City of Eustis

TO: HISTORIC PRESERVATION BOARD

DATE: MAY 8, 2024

RE: CERTIFICATE OF APPROPRIATENESS 2024-COA-06 CONSTRUCTION OF A NEW SINGLE-FAMILY RESIDENCE AT 805 EAST LEMON AVENUE (NORTHEAST CORNER OF SOUTH PRESCOTT STREET AND EAST LEMON AVENUE / ALTERNATE KEY 1189811)

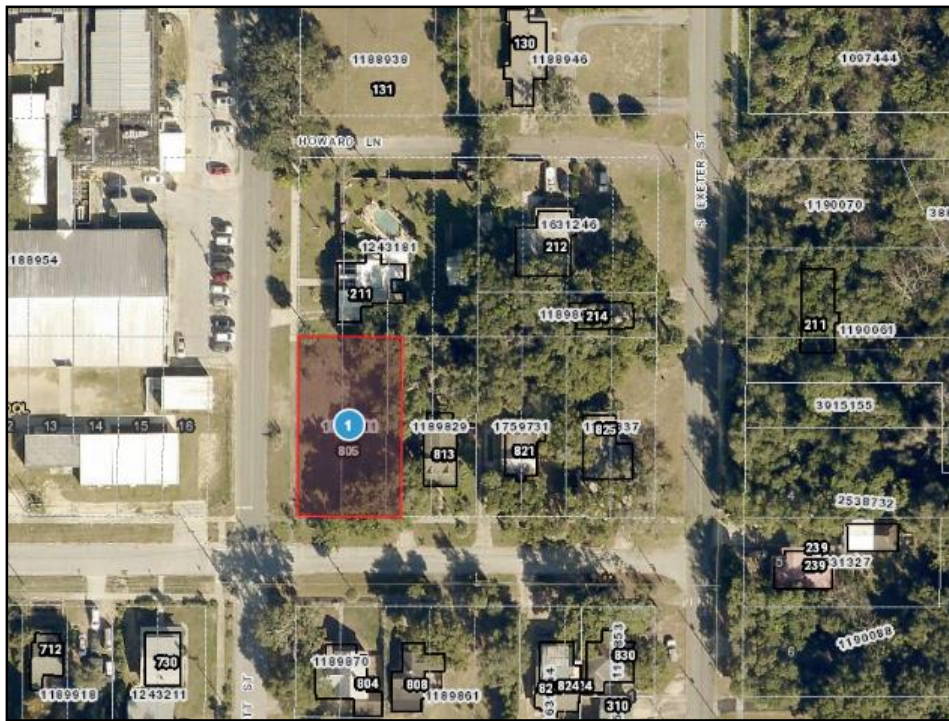
The new design is proposed as a two-story of approximately cumulative 1,690 sq.ft, which includes 1027 sq.ft living first floor and 663 sq.ft of living second floor.

The width of the building including the porch is 29'-2".

① PERSPECTIVE VIEW

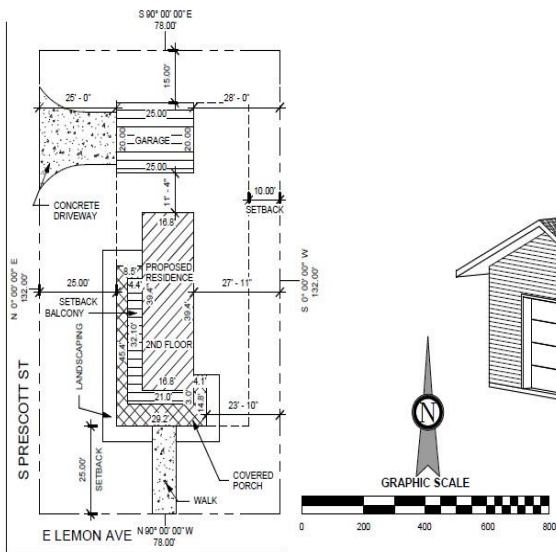
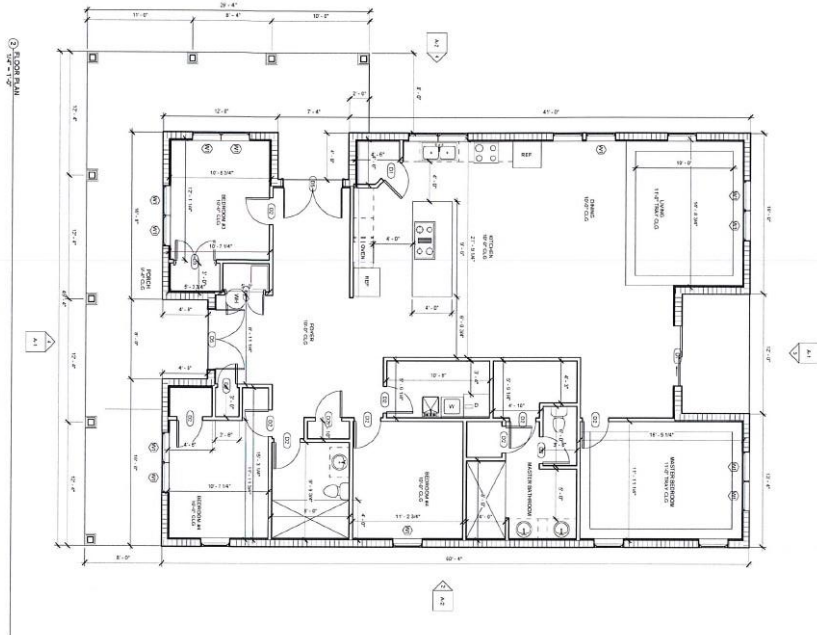
The previous design was a single-story of approx.2,311 sq.ft. and the width of the house was 49'-4".

The new design shows consistency with the Florida master site file, which describes the historic site architectural style as frame vernacular, in addition shows consistency with surrounding properties in the neighborhood and elsewhere in the Washington Avenue Historic District. (See attached site plan and renderings.)

Previous floor plan (1 Story)

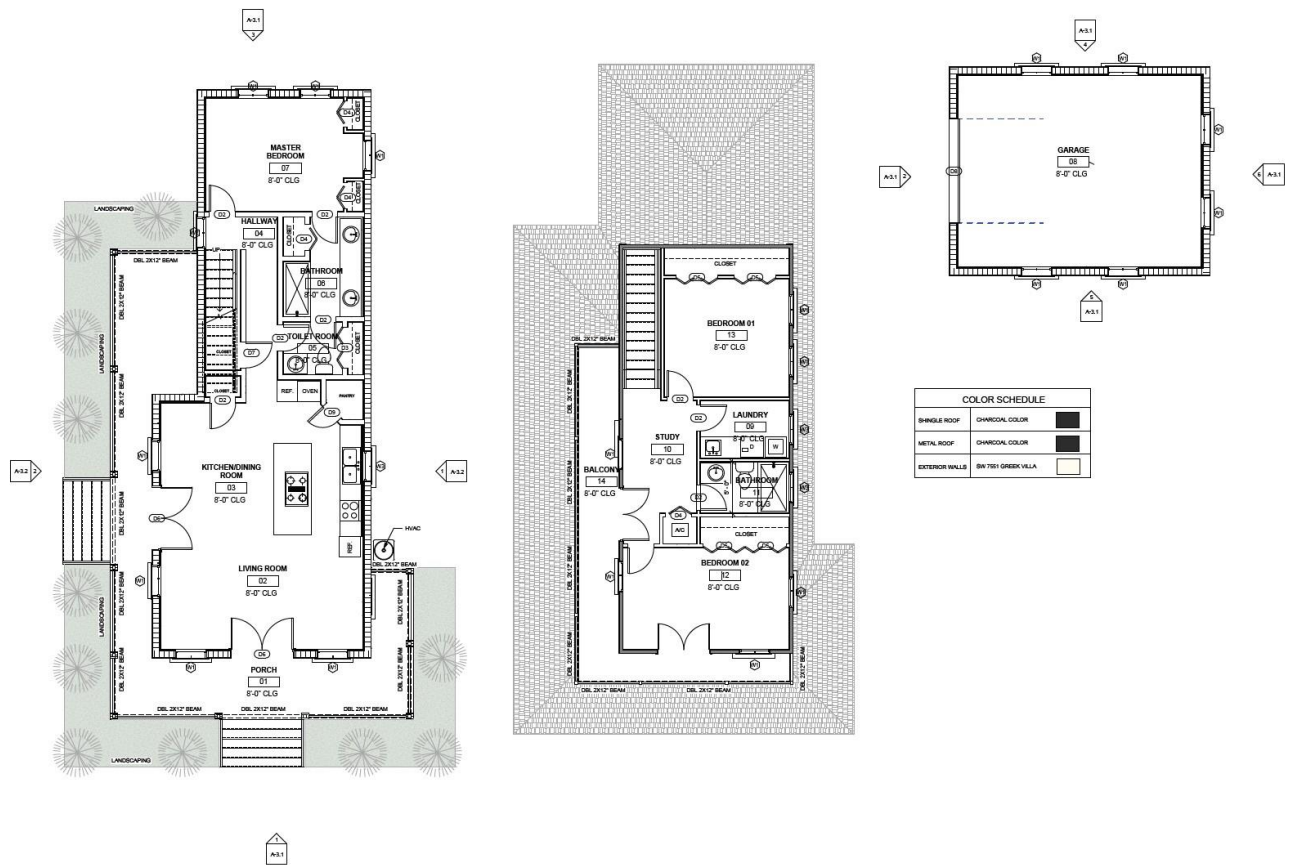
Homes in the frame vernacular style are typically rectangular and sometimes may be L-shaped to maximize cross ventilation. The proposed design floor plans is consistent with the architectural style.

Revised Elevations (2 Story)

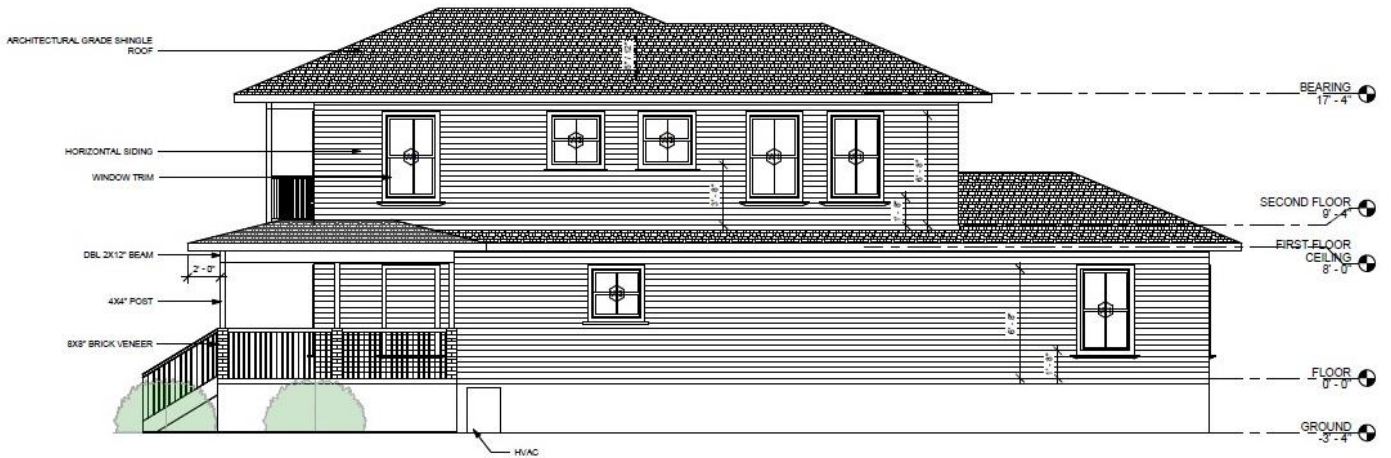
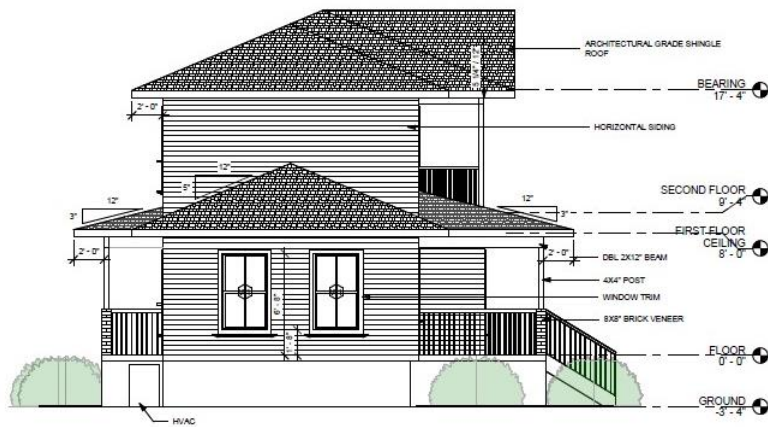
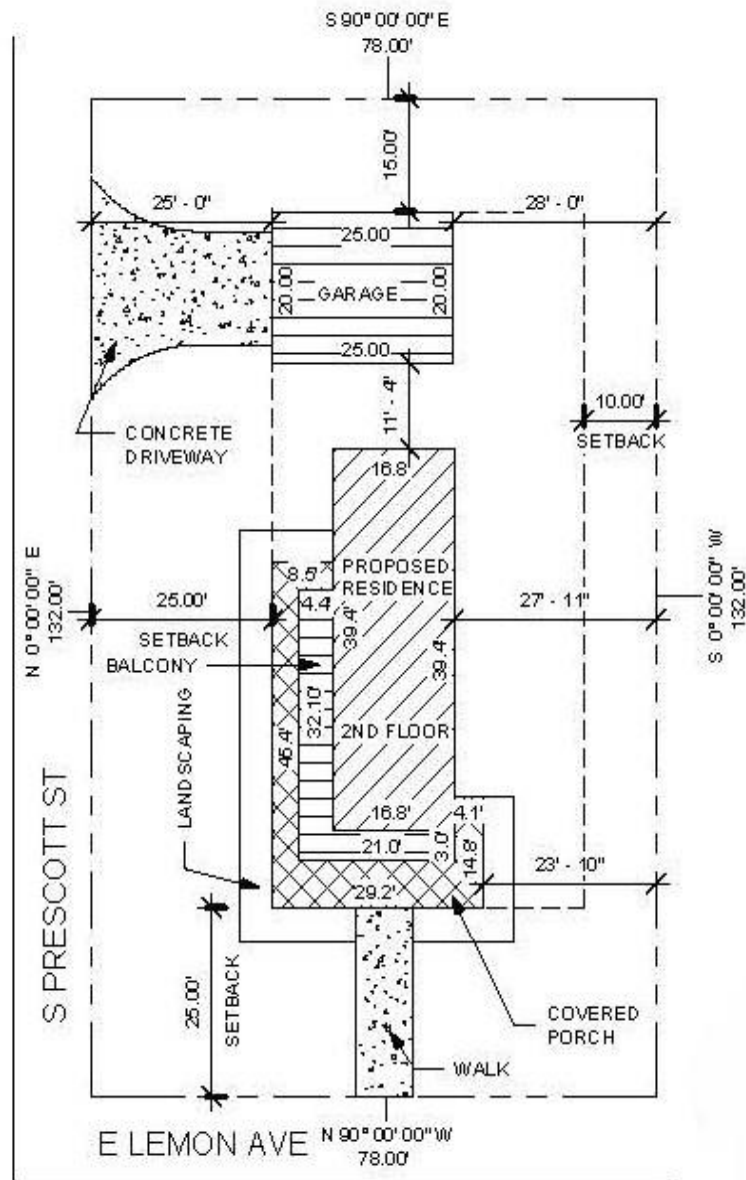
The proposed elevations are generally consistent with this. The proposed windows are making balance windows on elevations which is consistent with the neighborhood and the frame vernacular style.

The provided elevations show roof lines are generally consistent with this in the roof style provided.

The new designed elevations show a porch and balcony on first and second floor on both, side and front elevations, creating balanced elevations which is one of the most common features for frame vernacular architectural style.

The provided elevations show roof lines that reflect the typical design elements of the frame vernacular style. The roof line of the frame vernacular style is typically simple (hip or gabled) with deep overhanging eaves.

The proposed elevation's material is horizontal siding, Brick veneer and shingles for the roof, are all consistent with the common material for the frame vernacular architectural style and surrounding buildings.
